Thank you for notifying me by letter of April 29, 2013 and for this opportunity to comment on the above s75W application (MOD1 & PPR) that seeks to amend the PAC approved concept plans, conditions of consent and statement of commitments.

#### SPECIFIC OBJECTIONS to MOD1-PPR:

12.3 Subject Site Masterplan (REV B), Traffic, access and parking by Tony Owen – June 25, 2012.

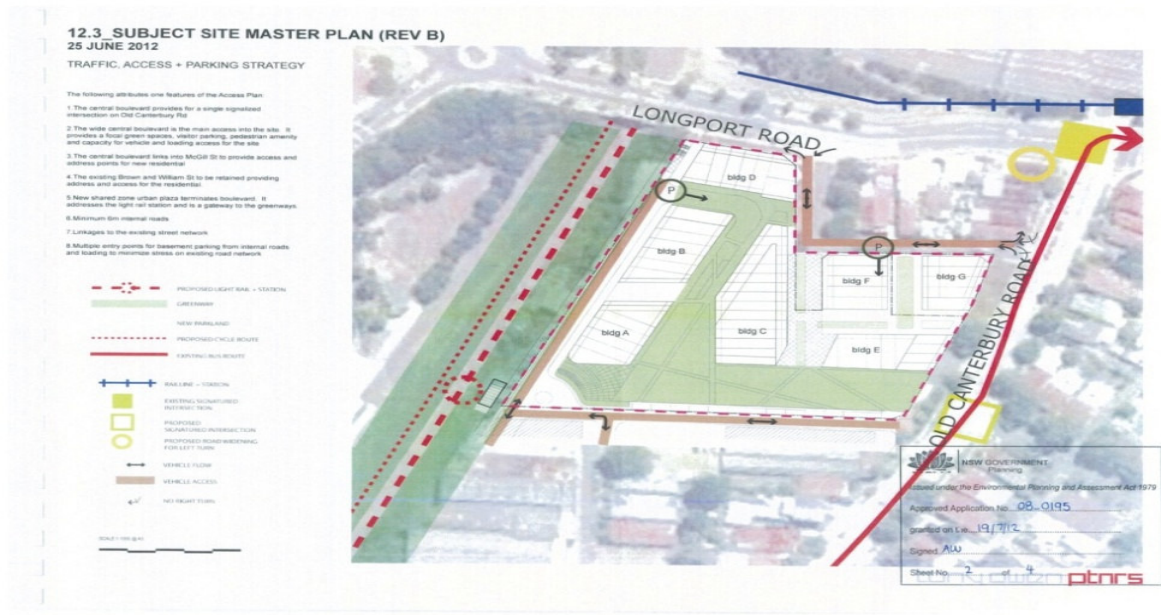
Note how the 'un-amalgamated' low-rise residential block to the NE of this plan has been blocked out and is therefore given no consideration in the DOPI approved plans.

### 12.3 SUBJECT SITE MASTER PLAN (REV D) 22 MARCH 2013

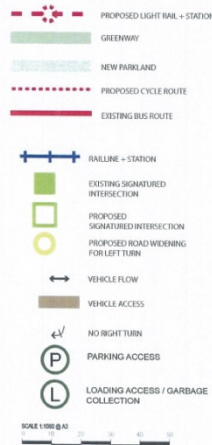
**For the very first time in REV D below** the car park ingress/egress entrances **are clearly marked**. NB: The loading area relocation that under PAC Part B2 was to be deleted from the concept and placed underground. (See later comments in this submission).

5. We object very strongly to the placement of one of the vehicular ingress/egress car park entrances in the middle of William St between buildings F and G.
6. Our concerns are very simple and include the incapacity of William St and Brown St to handle two car widths of traffic as is the case right now. We cannot believe that the proponent has chosen this 'worst' option to site a car park ingress/egress in this small Victoria era street given the

17. We also object in the PPR to the request to delete condition B2 – imposed as a modification by the PAC under Part 2 Modifications – that requires the deletion of the loading dock then located adjacent to Building D at ground level and for it to be relocated in the basement. We supported the PAC B2 proposal and with the move east closer to our properties we believe it may create unnecessary noise impacts and other issues despite it being located in the basement. See 12.3 (REV D).

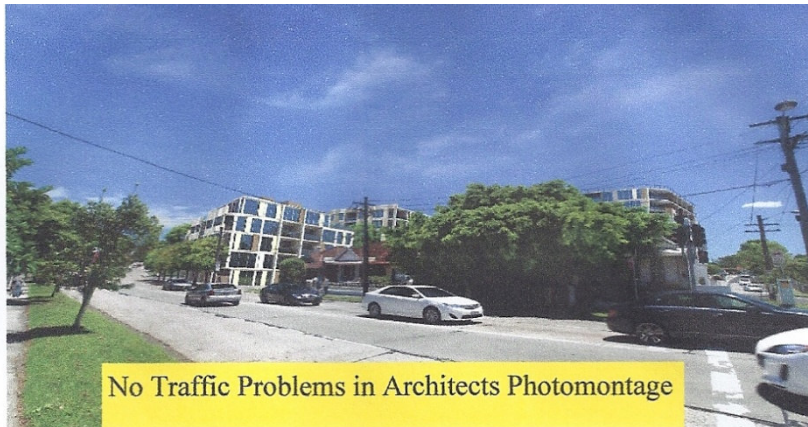
8. Specifically we object to having this car park entrance/exit sited little more than 8 metres from the front door entrance to our residences. Building close to one busy road was discouraged in the Metropolitan Plan but building alongside two busy roads shows a callous disregard for those most immediately impacted.

9. Furthermore, placing a car park entrance/exit into a major project of this nature in the middle of a narrow and small Council owned street is an astonishingly poor design option. It's also an unconscionable decision as there is no denying that this choice will have huge environmental and health impacts for the residents currently residing in the surrounding low-rise residential block.

Comparison of how beautiful the architects photomontage looks  
To how it looks in real life

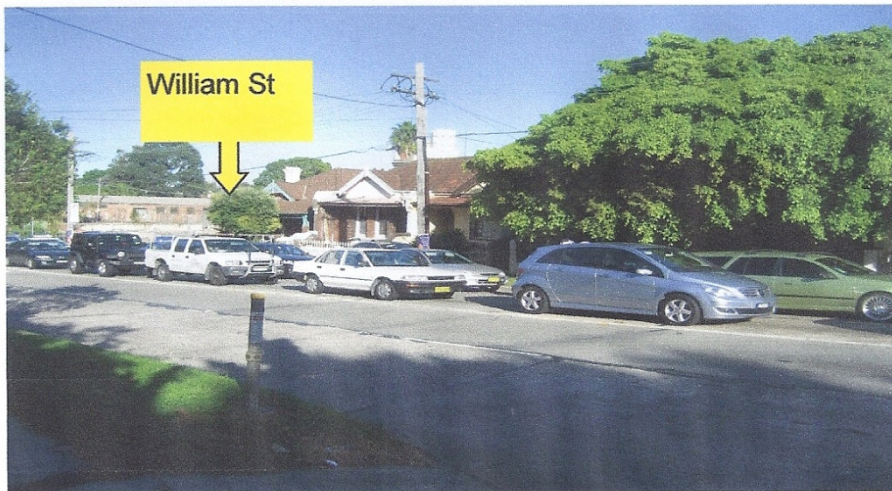
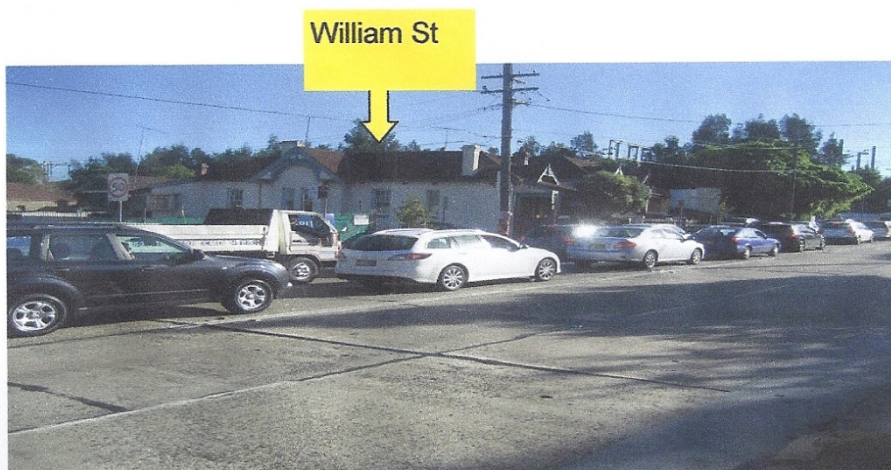
This comparison of the respective photomontage images requires little explanation.

Good luck to you If you lived in one of these apartments and you were getting out from the car park under building F to get out of William St onto Old Canterbury Rd In peak hour
